## **Product Change Notice (PCN)**

PCN Number: PCN-0451146R-01

Product(s) Affected: PJ-036CH

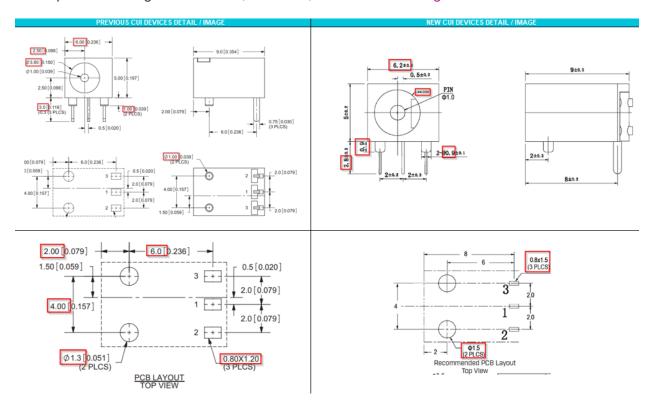
Reason(s) for Change: Manufacturing process improvements

Description of Change: Mechanical, electrical, and material changes as shown below:

MATERIAL	PLATING
center pin	brass	silver
terminal 1	brass	silver
terminal 2	copper alloy	silver
terminal 3	brass	silver
plastic	PA66

DESCRIPTION	MATERIAL	PLATING/COLOR
center pin	brass	silver
terminal 1	brasst=0.25	silver
terminal 2	brasst=0.25	silver
terminal 3	brass t=0.25	silver
housing	PBT (UL94V-0)	black
